Appl. No. 10/502,184
Amdt. dated Apr. 4, 2006
Reply to Office Action Mailed Jan. 11, 2006

REMARKS/ARGUMENTS

2/2 3/3

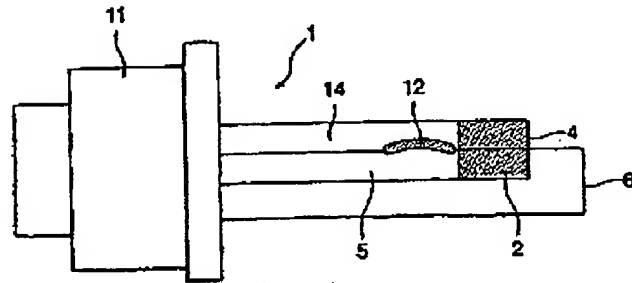
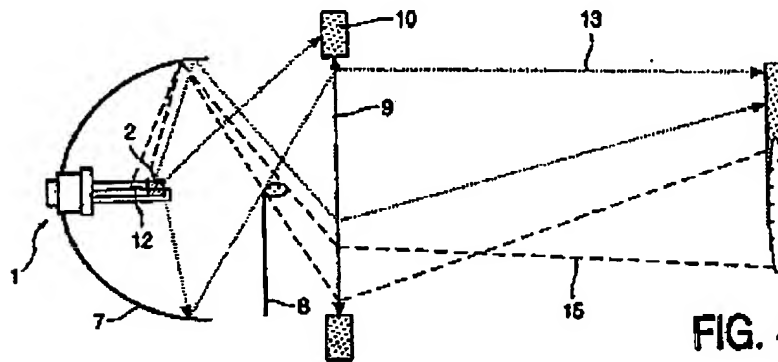
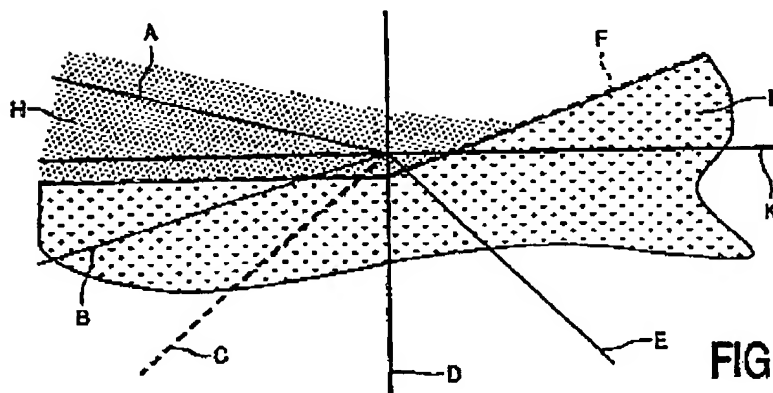
The third attached sheet of drawings changes the sheet containing Fig.'s 3-5, formerly sheet 2 of 2, to sheet 3 of 3.
